Subject ▶ Addition of Washer 4 and change of Screw 5

For Models ▶ 1050D

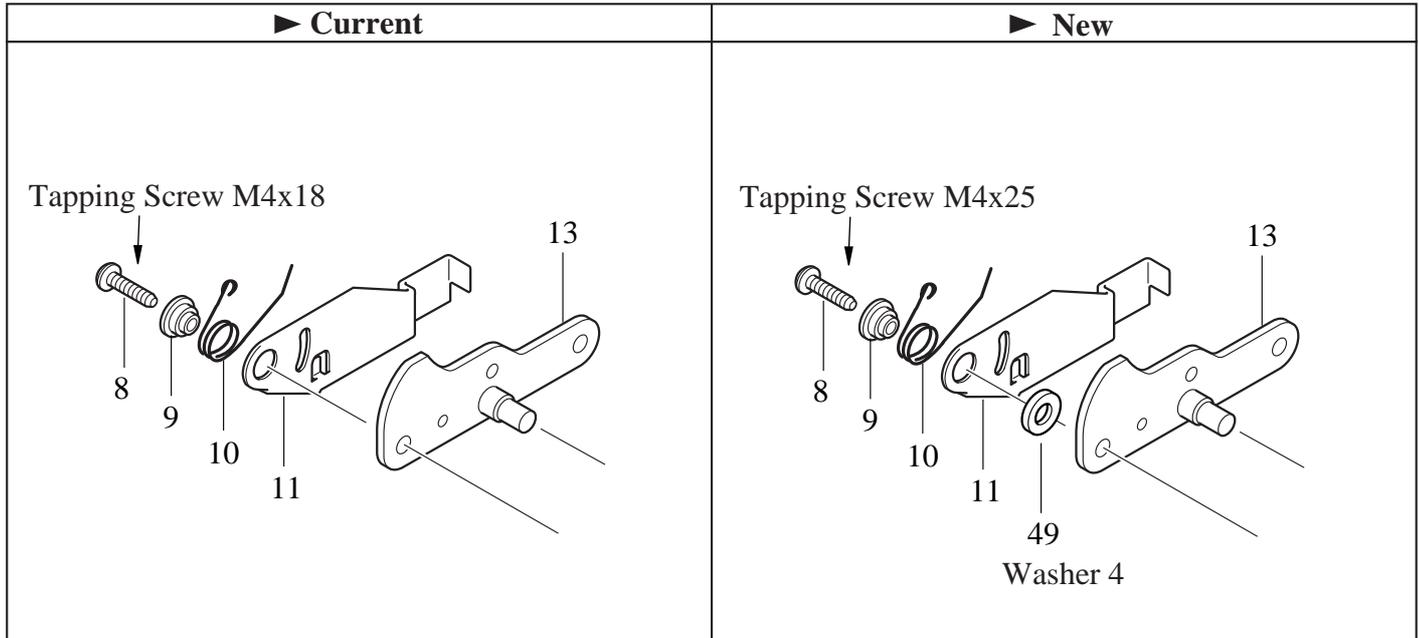
Description ▶ As illustrated below, Washer 4 has been added for improvement of endurance, accordingly Tapping screw has been changed.

| Item No. | Current part | Q'ty | I/C | New part | Q'ty | Note |
|----------|-----------------------------------|------|-----|-----------------------------------|------|----------------------------|
| 8 | Tapping Screw M4x18 265995-6 | 1 | <= | Tapping Screw M4x25 265999-8 | 1 | |
| 25 | Pan Head Screw M4x25 9111148-2 | 1 | <= | Pan Head Screw M4x30 9111158-9 | 1 | For attaching Set Plate |
| 49 | | | | Washer 4 941051-3 | 1 | |

1050D : From serial No.1001E
